GSC3574/3575 Firmware Release Notes

FIRMWARE VERSION 1.0.3.1 (First Version of Android 14)

GSC3574/GSC3575

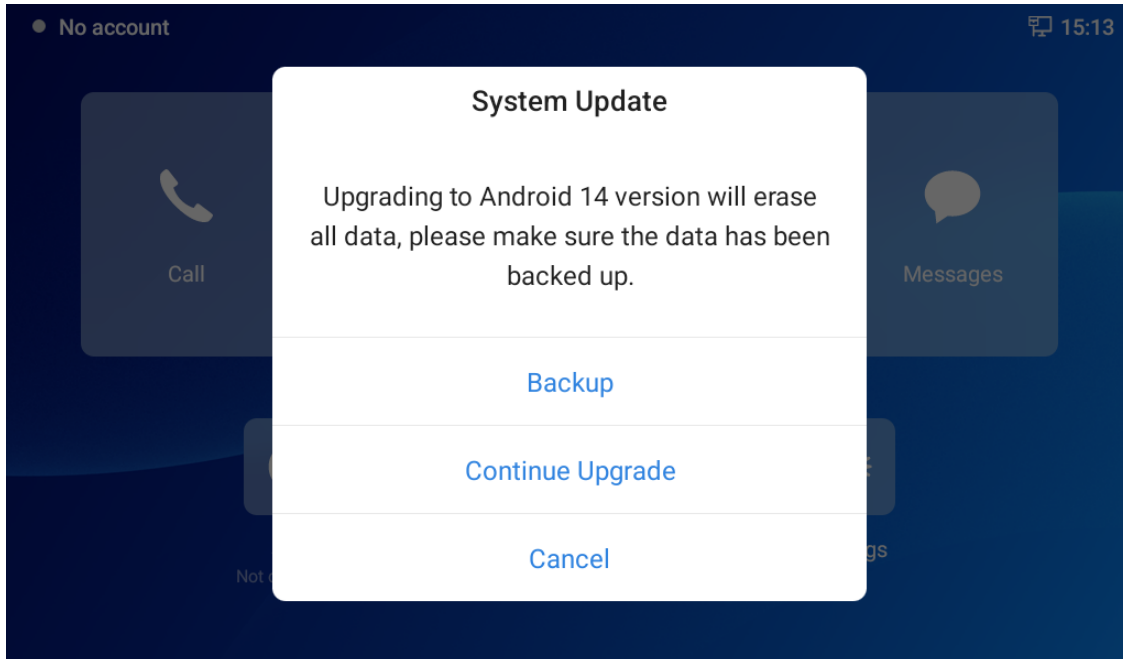
- **This is the first version of Android 14**
- **Once in Android 14, device can NOT downgrade back to Android 13**
- **All previous Android 13 firmwares must upgrade to 1.0.1.17 (backup the data), before upgrading to Android 14**
- **Once upgraded to 1.0.3.1, a factory reset will automatically be executed, please make sure to backup the data and configuration of the device, write down the default password, before upgrade from Android 13 (FW1.0.1.17) to Android 14 (FW1.0.3.1 or above)**
- **Please connect external storage device (SD card or USB Drive) to GSC3574/GSC3575, go to "Settings → Features → Backup and Restore" to backup the data before upgrade to 1.0.3.1 (Android 14), as shown in below screenshot:**

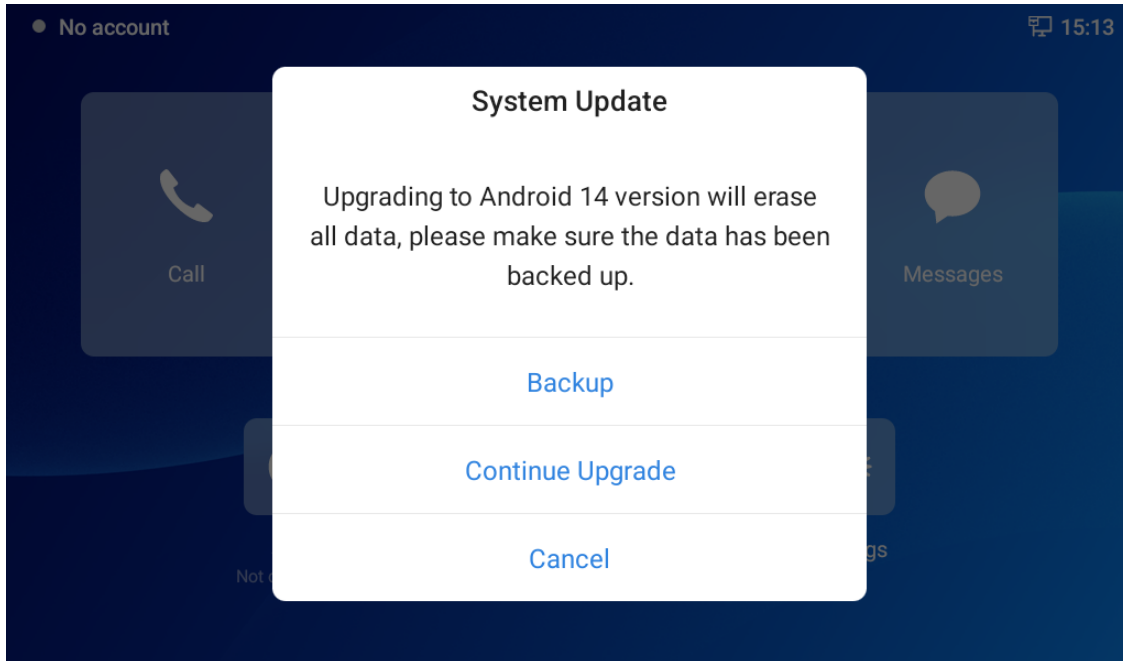
- **This is the last version of Android 13**
- **All previous (Android 13) firmwares must upgrade to 1.0.1.17 before upgrading to Android 14.**
- **Please connect external storage device (SD card or USB Drive) to GSC3574/GSC3575, go to “Settings → Features → Backup and Restore” to backup the data before upgrade to 1.0.3.1 (Android 14) , as shown in below screenshot:**
